Charlotte Department of Transportation

Memorandum

Subject: Rezoning Petition 15-073: Approximately 5.9 acres located on the west side of Archdale Drive also abutting Interstate 77 near the intersection of Archdale Drive and High Meadow Lane.

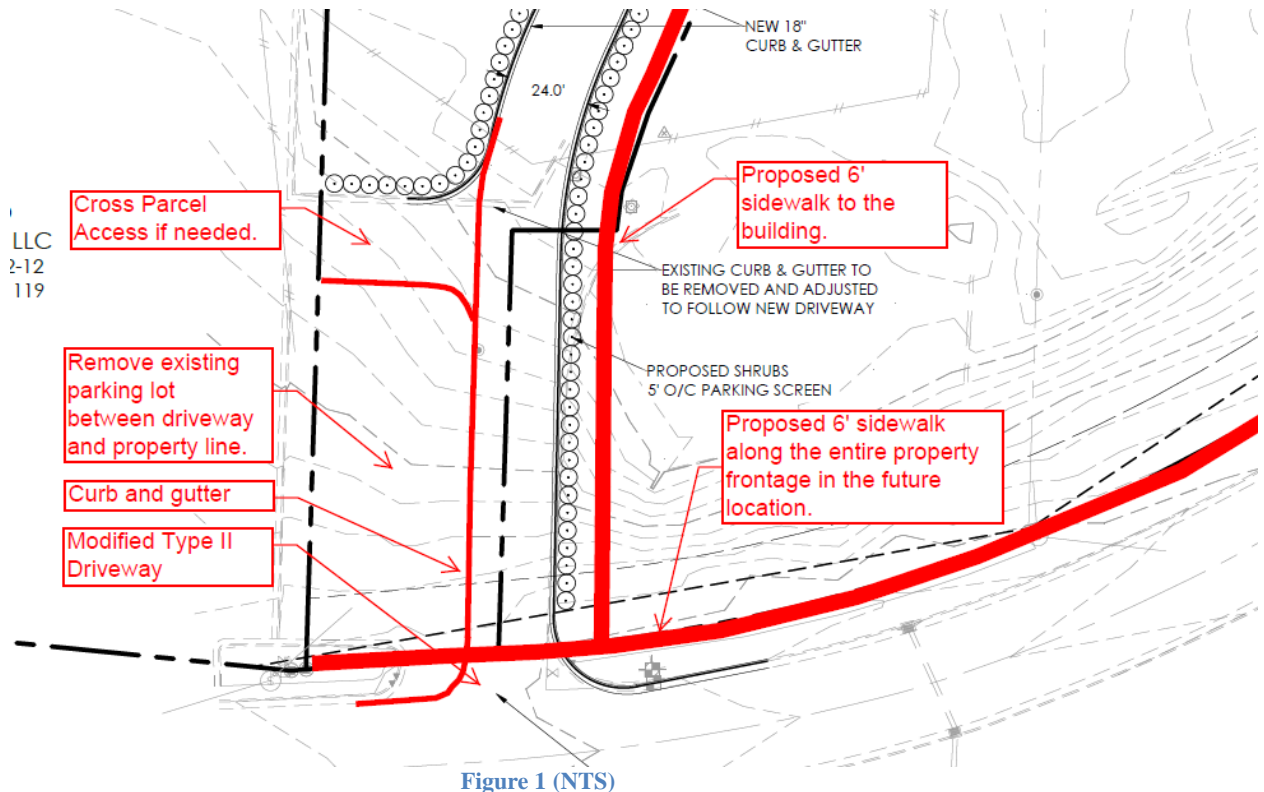
- a. Install 6' wide sidewalk along the site's frontage on Archdale Drive. The front of proposed sidewalk should be located 27.5' from the centerline of existing road (see conceptual sketch in comment #2).
6. CDOT requests that the petitioner modify the driveway entrance and internal channelization to resemble the below conceptual sketch (Figure 1):

7. CDOT requests the petitioner install a sidewalk that will provide pedestrian connectivity from the public right-of-way to the site (Figure 1).
